Determination 2025/031

The authority's decision to refuse to grant a building consent for building work to a relocated dwelling.

37B Freeburn Road, Pyes Pa, Tauranga

Figure 1: Site plan

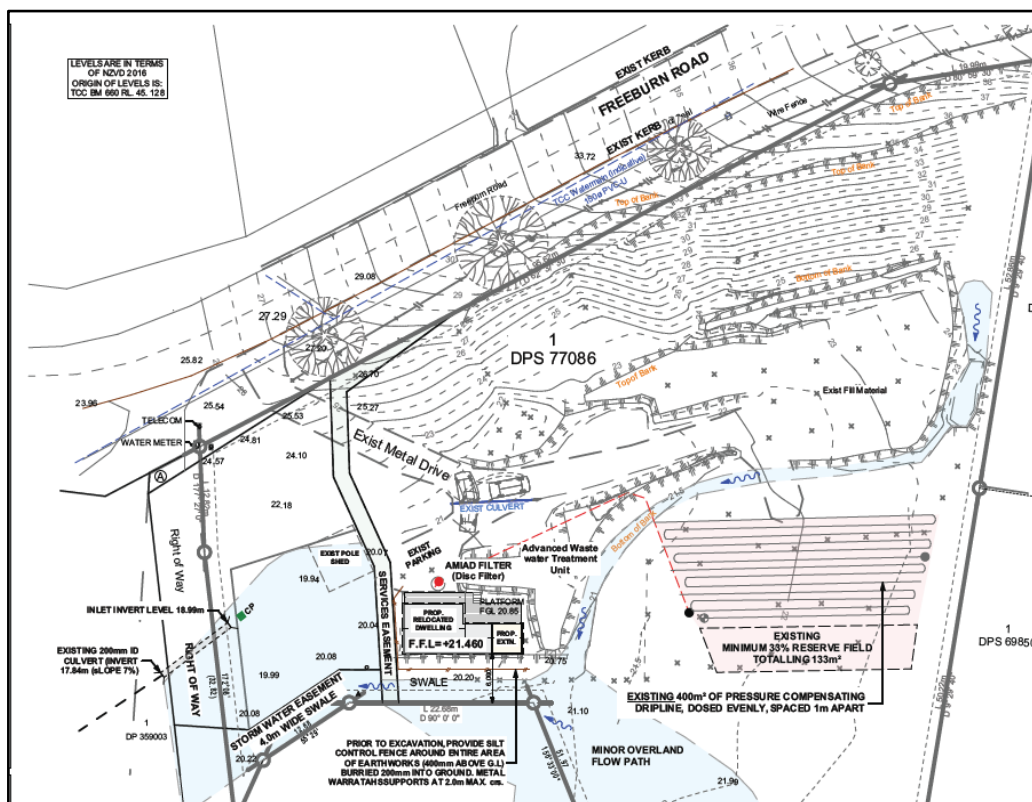
3.10. However, the authority has raised a valid view that the assessment appears to be based on a different situation from that presented in the building consent plans and specifications, such as where the authority highlights the risk assessment being “contingent on the construction of the driveway embankment”, which is not shown on the plans and specifications.

3.11. I agree with the authority that contradictory information exists between the situation identified in the geotechnical report and that presented in the building consent documentation.

3.12. This leads to a lack of clarity in terms of the extent to which the authority can rely on the conclusions of this geotechnical report in relation to the building work presented in the plans and specifications.

Figure 2: Hazard modelling information from the authority

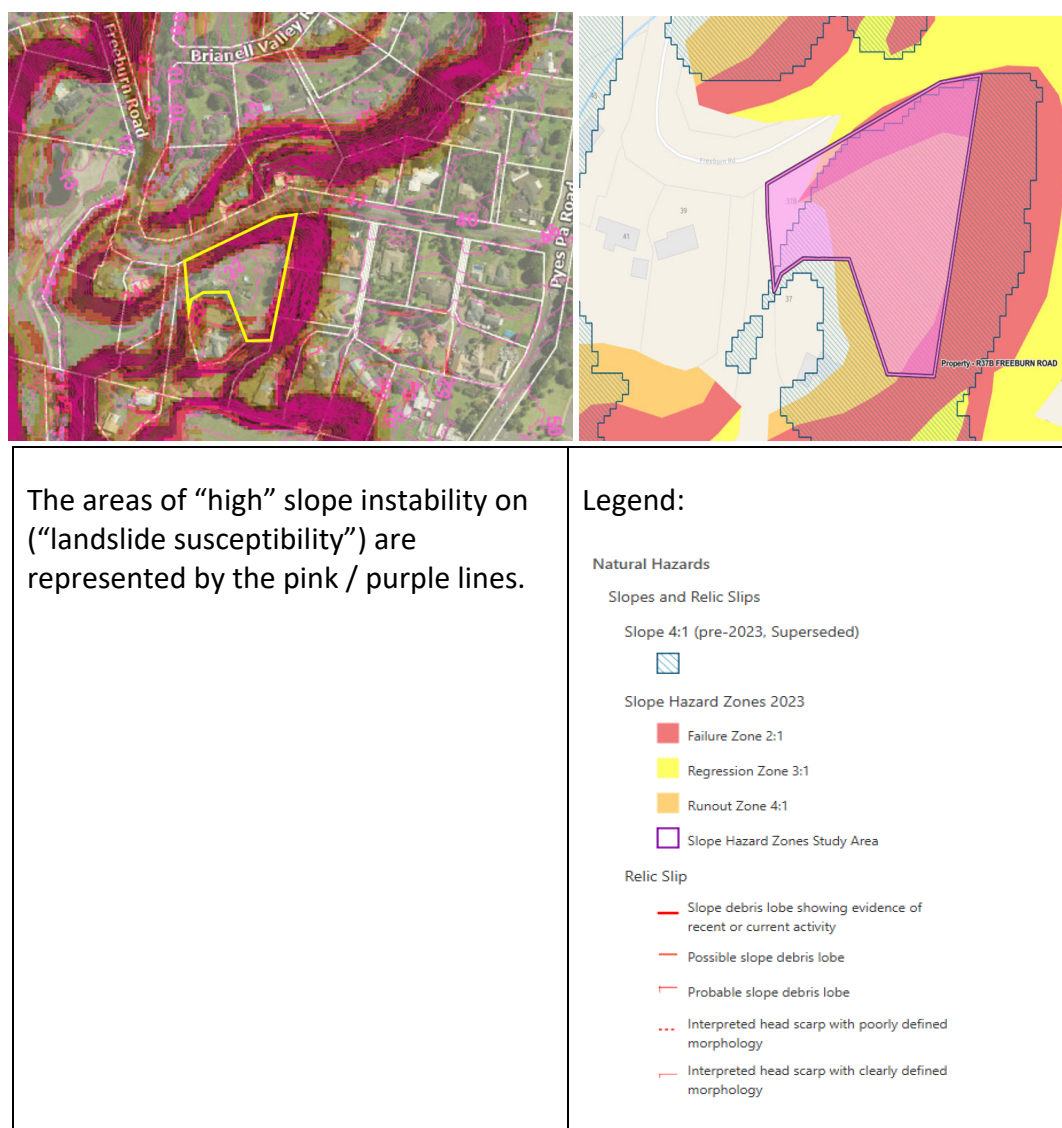
3.3. The authority's maps⁶ identify some areas of slope instability across the north, east, and south boundaries of the property:

- 3.2. Based on the information available from the authority's maps, and the reports provided by the geotechnical engineers, there is evidence to indicate some of the property is in an area subject to (or likely to be subject to) land instability (slippage). The authority refers to a 'relic slip' ie "areas affected by/ground features formed by a past landslide".

- 3.6. The authority's maps identify the areas of the property most likely to be affected by any land instability are along the north, east and part of the south boundaries. Due to the size of the property, I do not consider it appropriate to identify the whole property as the land intimately connected to the building work.

- 3.7. The geotechnical addendum report indicates the proposed relocated dwelling is not being positioned in the mapped slip area and it is "outside the 1V:3H runout zone and on the outer edge of the 1V:4H zone"

Figure 3: Swale

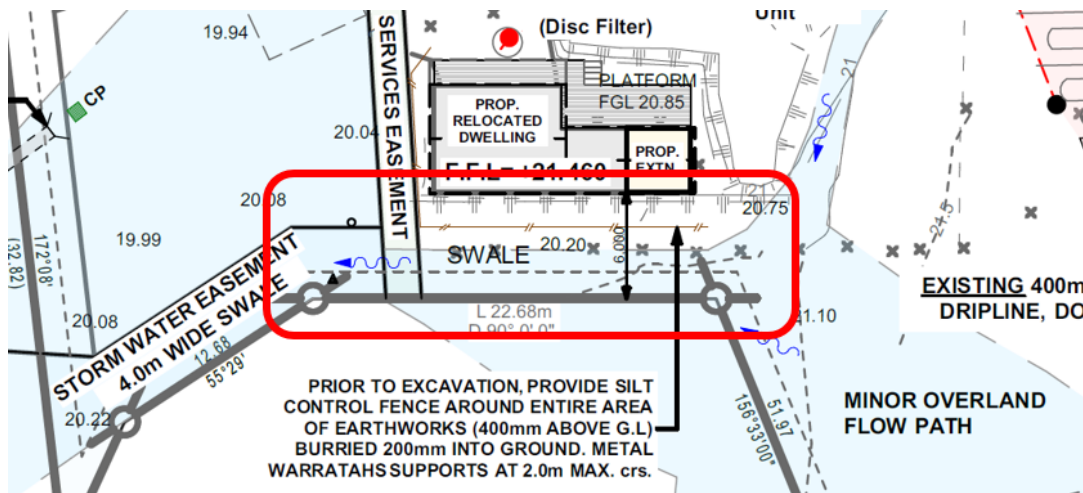
- 5.2. I have assumed the authority's reference to "building's runoff catchment area" refers to the roof of the relocated dwelling and the associated extension.
- 5.3. The building work includes installation of two new downpipes and below ground surface water drainage system in association with installation of the relocated dwelling and construction of the new extension at the property.
- 5.4. A new swale is to be formed close to the south side of the relocated dwelling adjacent and parallel to part of the property's southern boundary (shown by the red rectangle below).

- 5.5. The new swale appears to be intended for the purpose of re-directing all (or part) the existing overland flow path around the south side of the relocated dwelling (between the location of the dwelling and the nearby property boundary to the south of the swale).
- 5.6. It appears the ground level at the property has already been raised at and immediately adjacent to the proposed location for the relocated dwelling.

- 5.7. The surface water is being directed to an existing culvert located to the west side of the property.

- 5.35. It is not clear how the other properties may be affected by the increased velocity of surface water through the new swale. The report from the civil engineer did not reference or include analysis regarding the requirements of clause E1.3.1.
- 5.36. In this case, the plans and specifications do not demonstrate compliance with Clause E1 Surface water to the extent that the test under section 49(1) requires, therefore there are grounds on which to refuse to issue a building consent.
- 5.37. I do note, the authority's reasons for refusal, as stated in the written notice, should have been more explicit, specific, and clear.
